From: [REDACTED]
To: [REDACTED]
Sent: 3/3/2021 8:49:08 AM
Subject: RE: O8W-PM [REDACTED] - Bucks Creek 1101 Phase 1,2&3 - Pre-Engineering Meeting

Bucks Creek 1101- PM# [REDACTED] Overview Map

Subject: O8W-PM [REDACTED] Bucks Creek 1101 Phase 1,2&3 - Pre-Engineering Meeting

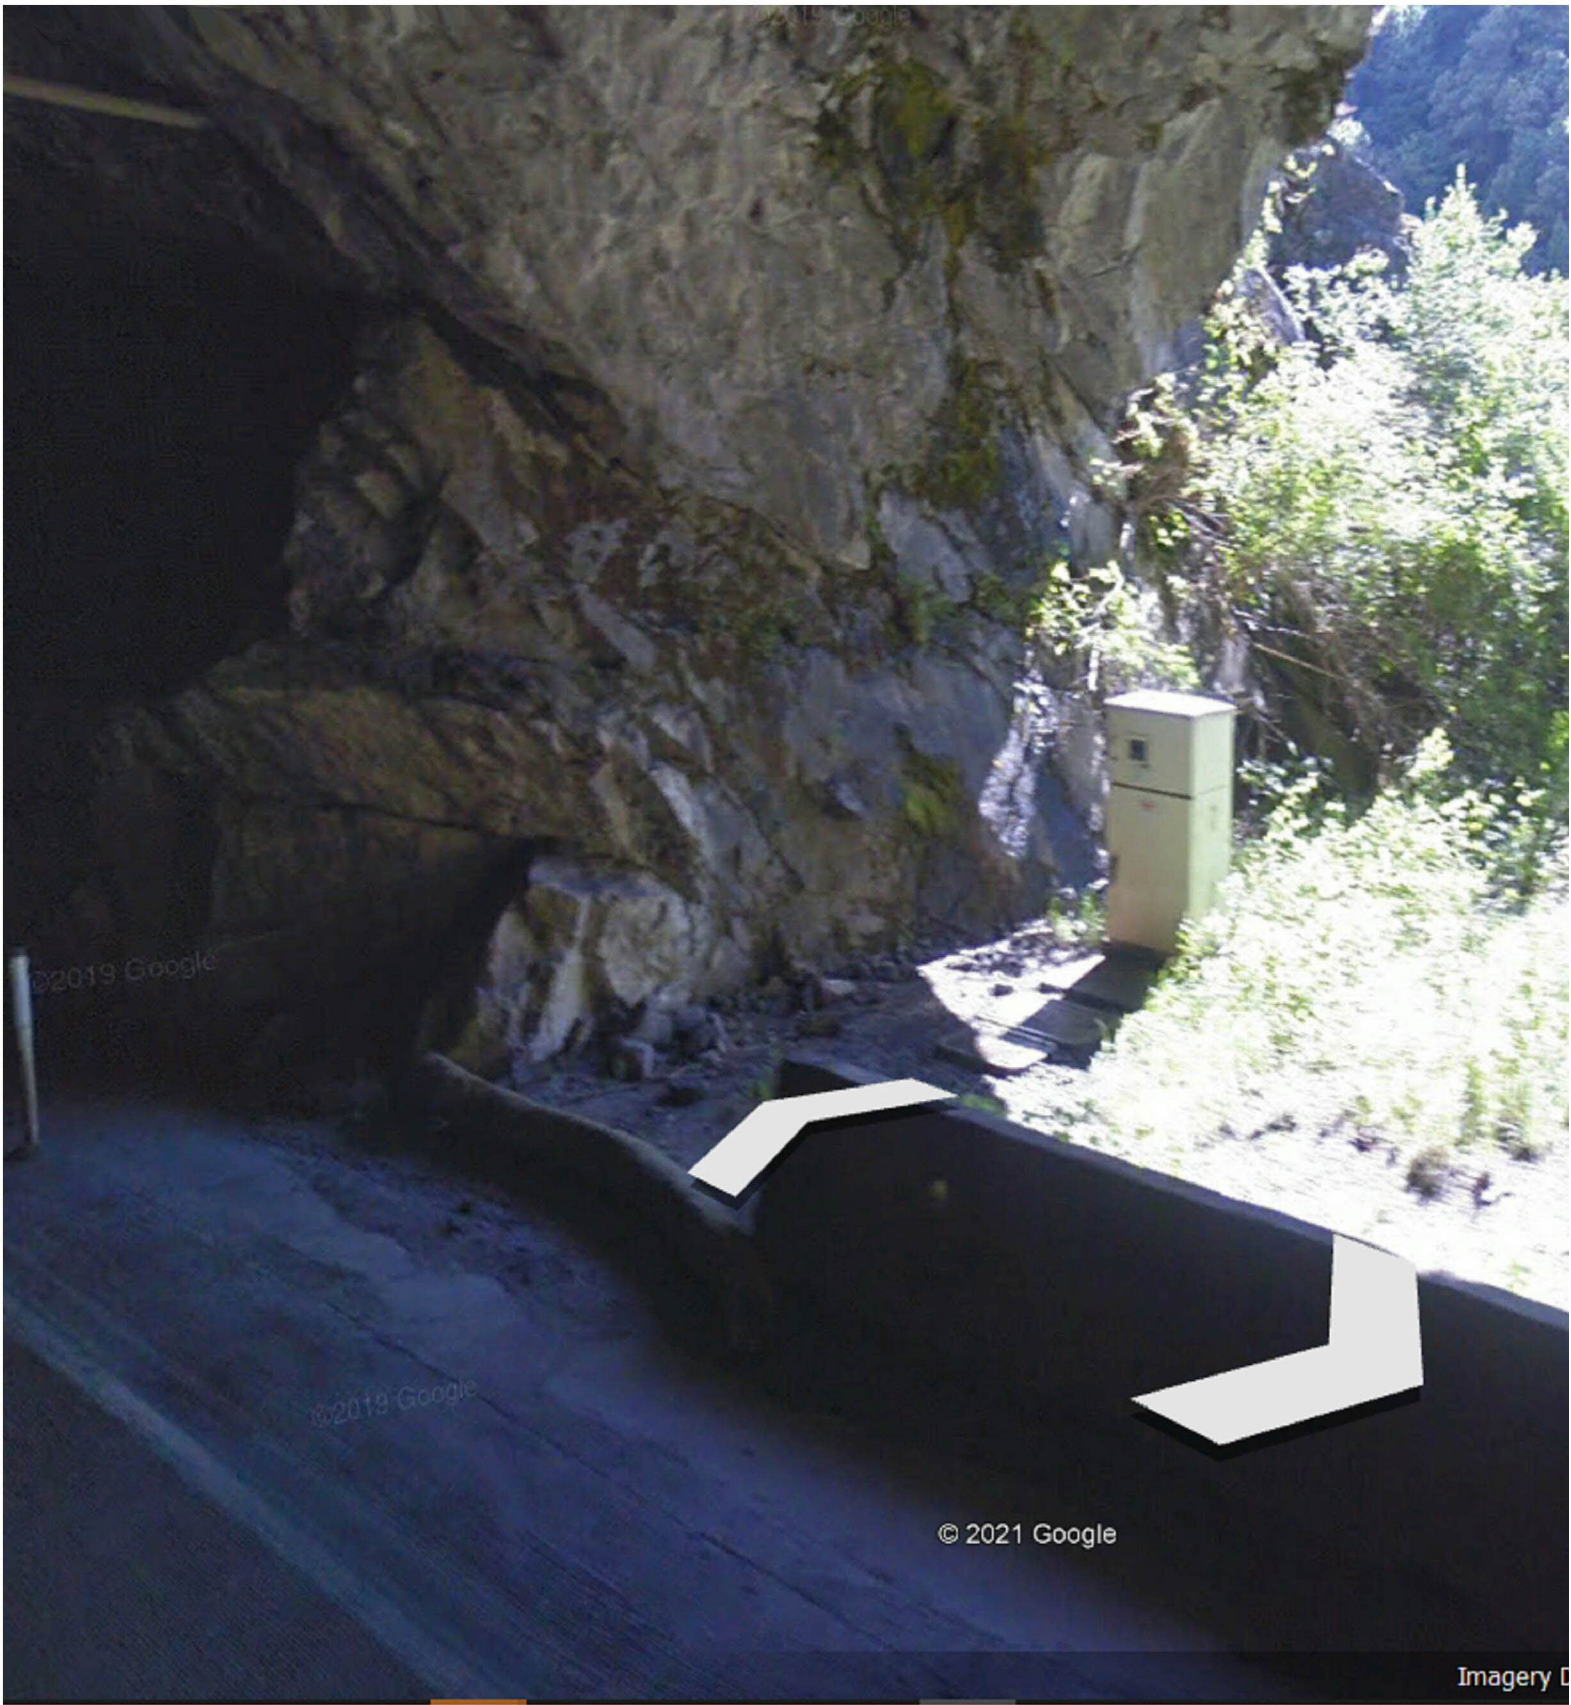
Attached are the 'base-map' limits in a kmz. file. As you will see, we need our base-map to go about ~100' into the tunnel at the south end (see pedestal in picture below....please begin about ~50 beyond this point which is about ~100' beyond the Cresta Dam).

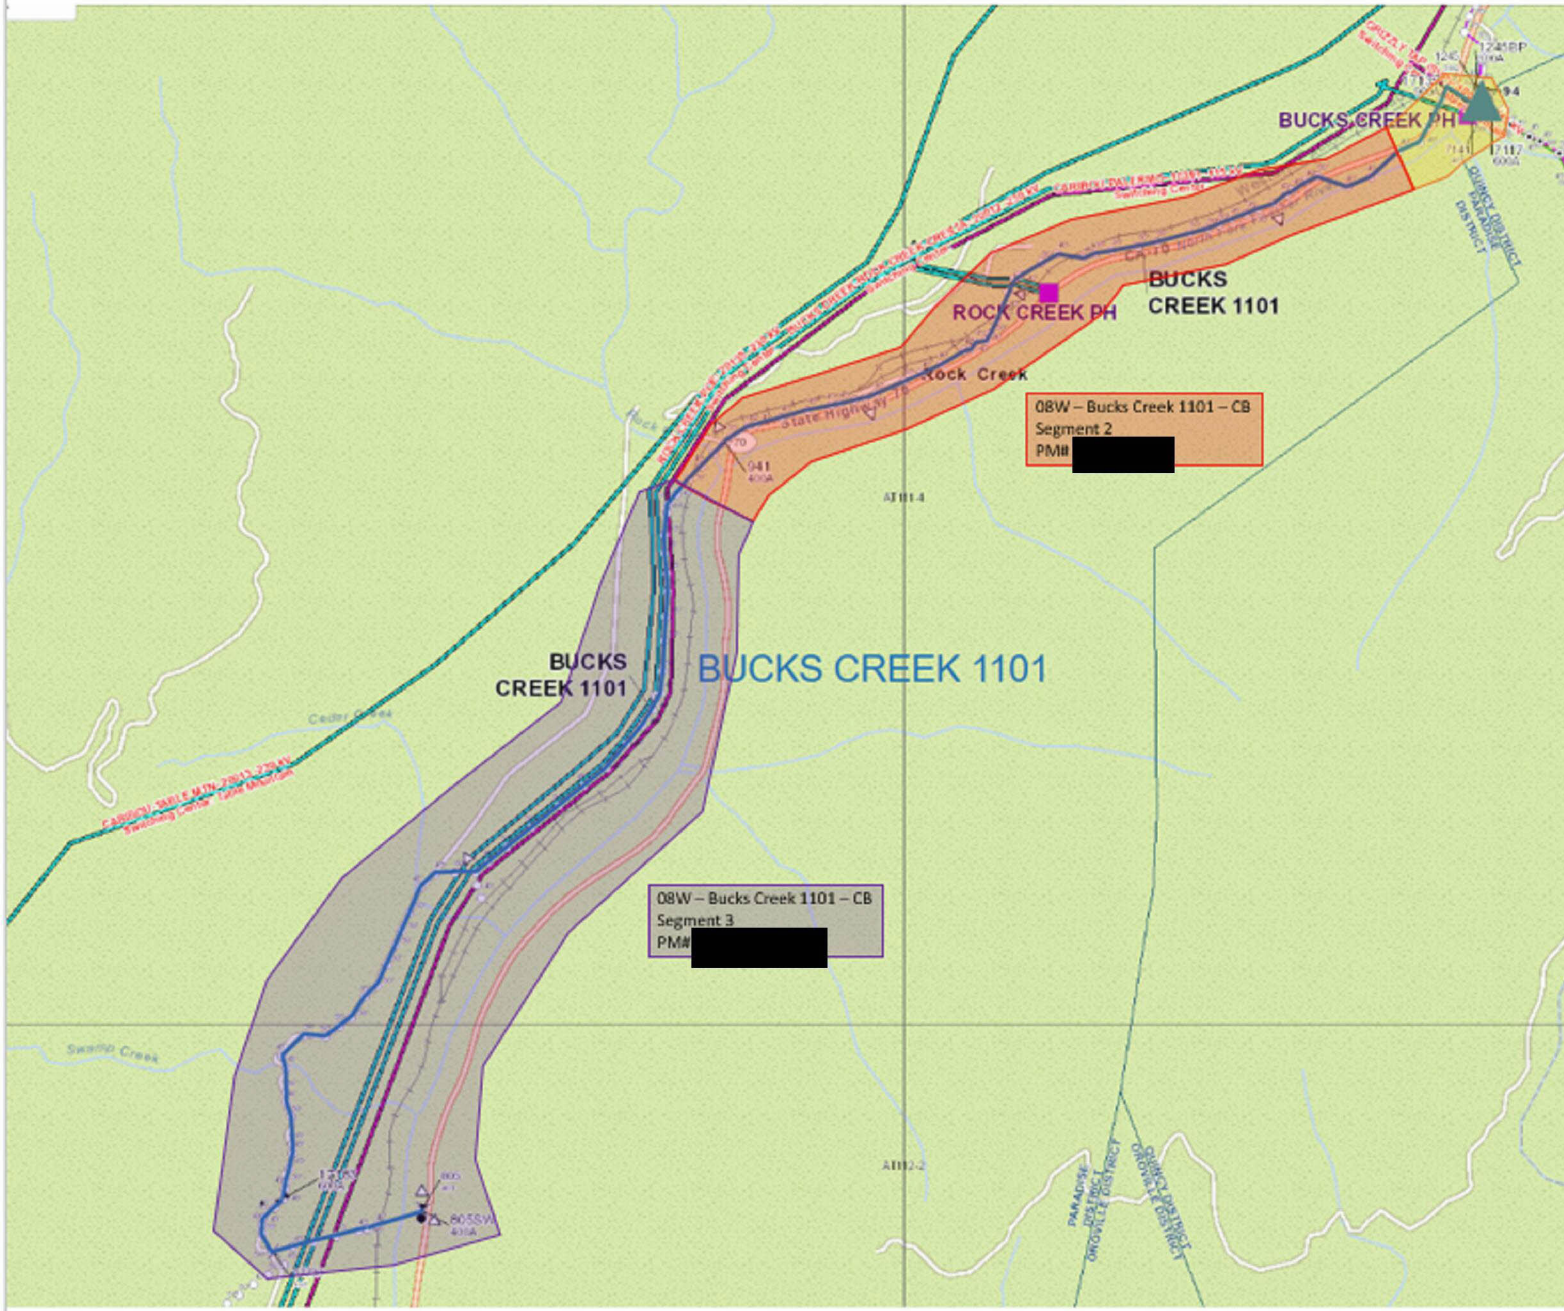
We want to end the base-map at the sign location below which is roughly at MM (Mile Marker) 5.10.

3. Rock Creek Bridge Crossing

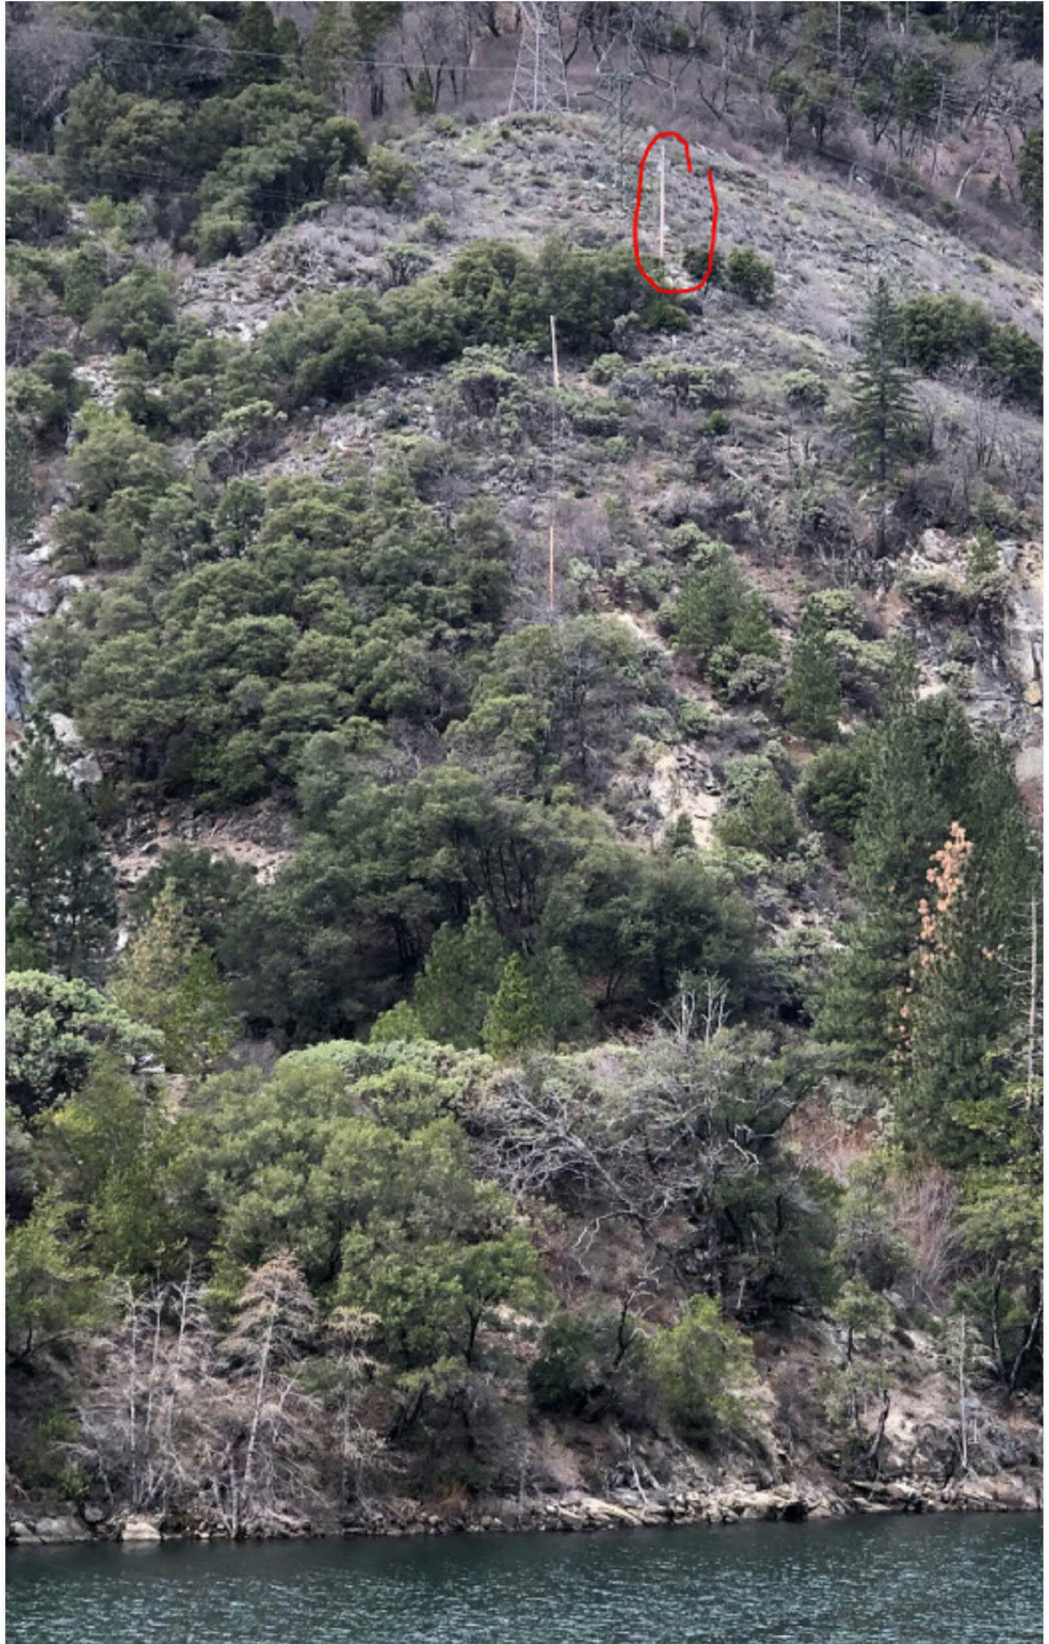
- a. Scope is not clear for this crossing since it leads us to a 'what-if' scenario of, if [REDACTED] doesn't allow the conduits to be attached to the existing bridge we should span the river OH. This will need to be discussed with [REDACTED] to first determine 'if' we can attach to their bridge before scope is locked.
